UNITED STATES
DEPARTMENT OF THE INTERIOR
BUREAU OF LAND MANAGEMENTFORM APPROVED
OMB NO. 1004-0135
Expires: July 31, 2010**SUNDRY NOTICES AND REPORTS ON WELLS**
*Do not use this form for proposals to drill or to re-enter an abandoned well. Use form 3160-3 (APD) for such proposals.*5. Lease Serial No.
Multiple--See Attached

CHEVRON USA INC RESPECTFULLY REQUESTS THE ABILITY TO BATCH DRILL THE SALADO DRAW PAD 3. THE WELLS INCLUDED IN THE SALADO DRAW PAD 3 INCLUDE:

Changes to APD for Federal Well

Summary of Changes to APD Submission

TA Cap, EBS-F-RH, 9"
13-5/8" SM
Part # 399984 - Rental

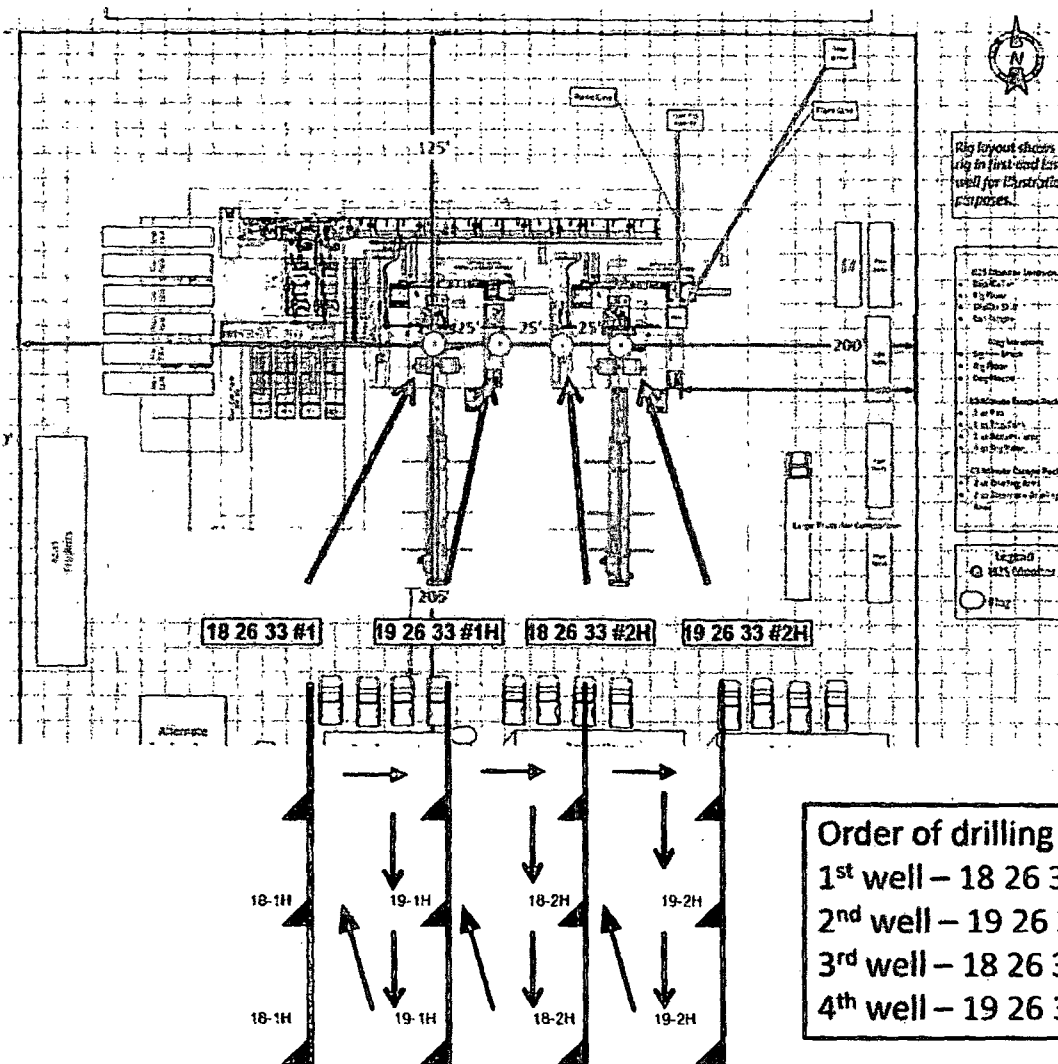
1. Drill 17-1/2" surface hole with fresh water to planned casing set depth with 10' rat hole.
2. Run casing as stated by approved APD, land out wellhead, and cement.
3. Dress out 13-5/8" 5M SH-2 wellhead and install/secure with temporary abandonment cap, and a pressure gauge will be installed. Reference image below Part # 399984
4. Skid to next well according to below "Drill Order"

Batch Drilling Sequence

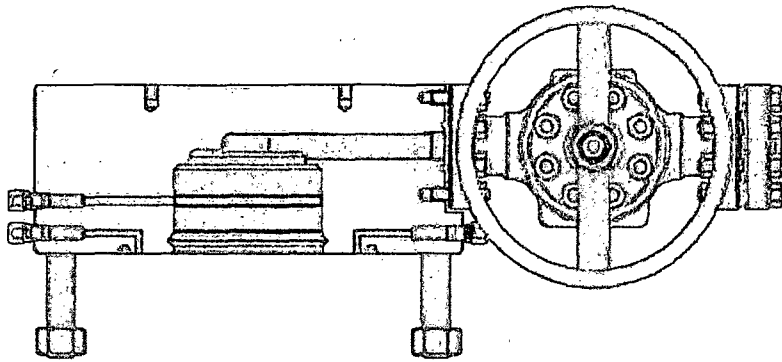
Summary: Variance to batch drill the Salado Draw pad not requested in original submittal.

Variance to batch drill not requested.

Chevron respectfully request the ability to batch drill in the SALADO DRAW (18-19) 26 33 PAD (3RD). The summary provided is a brief description of the main operational sequences for drilling and casing the four wells listed.

- Once the Rig is on location, it will drill the above mentioned wells in conjunction using batch drilling.
- BOP/BOPE test to be conducted per Onshore Oil and Gas Order No. 2 as soon as the Rig is rigged up on well and each time the BOP/BOPE is nipped up. CIT for all casing shall be performed and results recorded on subsequent sundry.
